SUBDIVISION REVIEW SHEET**CASE NO.:** C8-2020-0037.1A**COMMISSION DATE:** Sept. 21, 2021**SUBDIVISION NAME:** Marshall Ranch Subdivision**ADDRESS:** 1300 Lost Creek Blvd**APPLICANT:** Eanes Marshall Ranch, LP (Linda K. Haines)**AGENT:** Jonathan Fleming (KTCivil)**ZONING:** SF-2 (single family residence)**AREA:** 37.23 acres**LOTS:** 55**COUNTY:** Travis**DISTRICT:** 8**WATERSHED:** Barton Creek & Eanes Creek**JURISDICTION:** Full Purpose**SIDEWALKS:** Sidewalks will be constructed along Eanes Homestead Road, Eternity Terrace and Marshall Ranch Road.**DEPARTMENT COMMENTS:**

The request is for the approval of Marshall Ranch Subdivision, a subdivision out of the approved Marshall Ranch Subdivision preliminary plan, comprised of 55 lots (49 single family) on 37.23 acres.

CITY OF AUSTIN –DEVELOPMENT SERVICES DEPARTMENT
SUBDIVISION APPLICATION – MASTER COMMENT REPORT

PROJECT NAME: Marshall Ranch
 LOCATION: 1300 LOST CREEK BLVD

PROJECT NO.:
229-040
DRAWING NO.:
229-040-PL-R2
PLOT DATE:
07/23/2021
PLOT SCALE:
1"=100'
DRAWN BY:
RGH
SHEET
01 OF 04

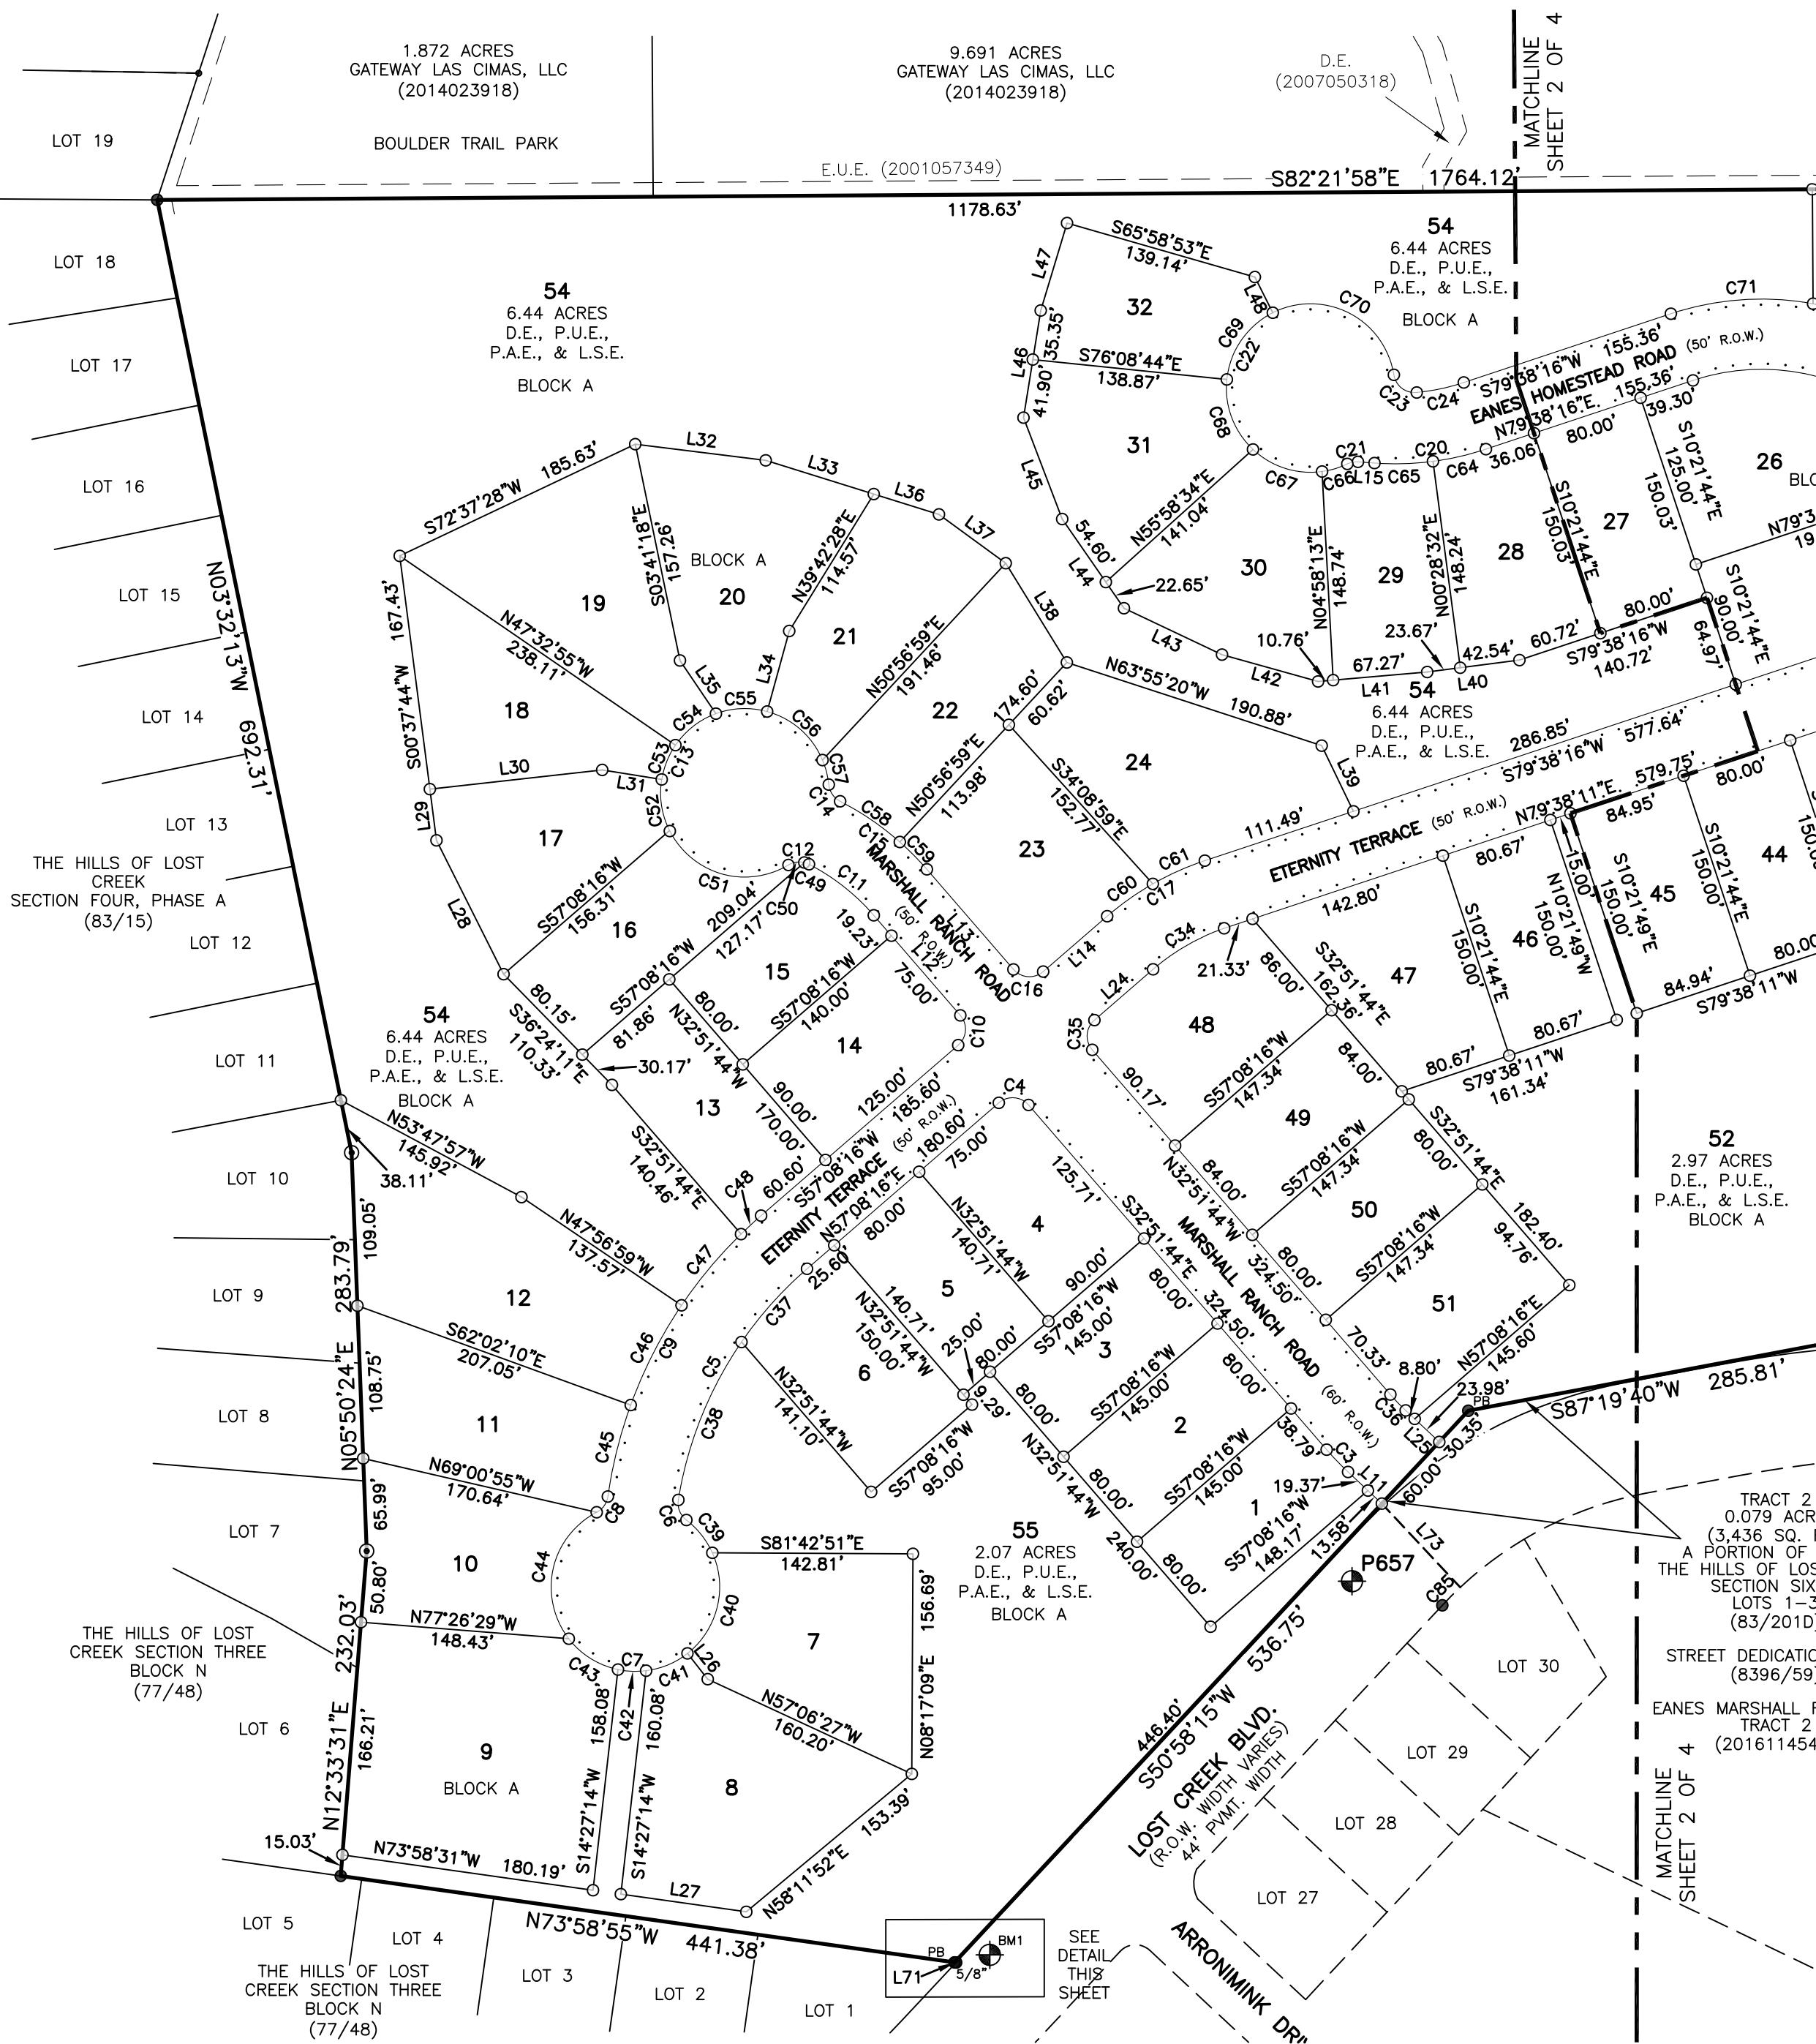
- EV 01 Remove plat note number 24. This note is not required.
- EV 02 Provide a conceptual erosion & sedimentation control plan along with the fiscal estimate for erosion/sedimentation controls and revegetation based on ECM Appendix S-1. A conceptual ESC plan is necessary to assess the accuracy of the ESC fiscal estimate. ESC fiscal surety must be posted with the City of Austin prior to Plat approval. Additional fiscal posting might be required at the time of subdivision construction plan ESC review.
- Sites with a limit of construction greater than one acre must include a \$3000 per acre LOC clean-up fee in the fiscal estimate. [LDC 25-8, Subchapter A, Article 5; ECM Appendix S-1]

EV 03 Revise plat note number 26 to state: "The maximum portion of any commercial, multi-family, or single family/duplex lot that may be established as turf or landscaped area is 15 percent. However, no lot shall be restricted to less than 2000 square feet of turf or landscaped area. Undisturbed natural areas or areas restored to natural conditions shall not be considered landscaped areas or turf." [LDC 25-8, Subchapter A, Article 13; ECM 1.6.9.2.E]

SR 2. Remove the following plat notes as they are not appropriate for the plat: 1, 18, 20, 24, 25, 26, 28 & 29.

Lot 52 does not have frontage to Loop 360. Correct note 31 to reflect the correct lot fronting Loop 360.
